Drainage Letter

**Viewpoint Estates
Filing No. 2**

Project No. 61099

PCD File No. SP-21-005 & SF-21-042

MVE PROJECT 61099
PP-DRN
MVE DRAWING

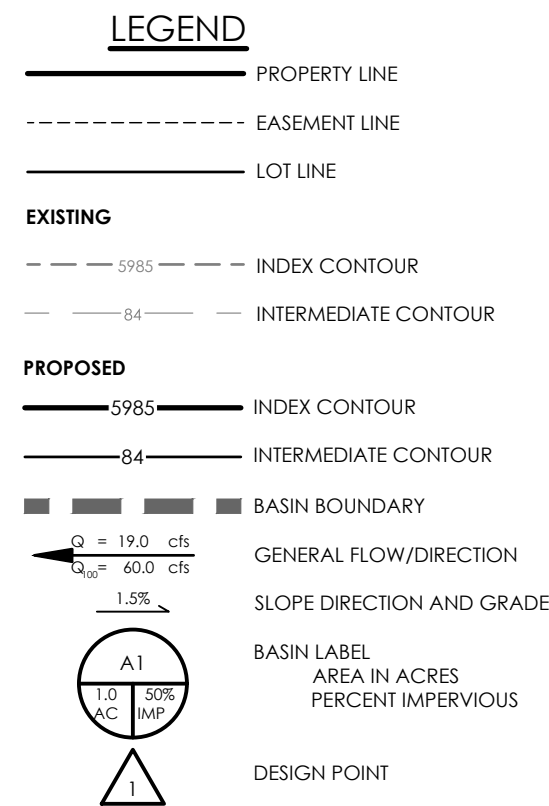
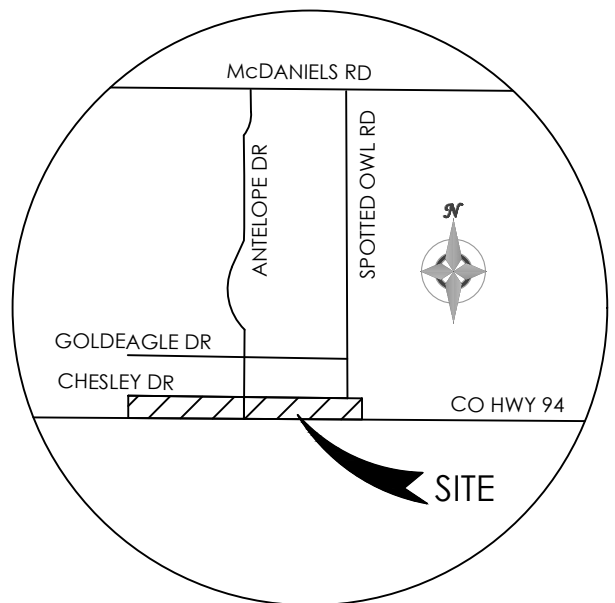
Unresolved from Submittal 2 - Define hatching in legend. Are these the detention ponds?
Also Call out and clearly label detention pond areas.
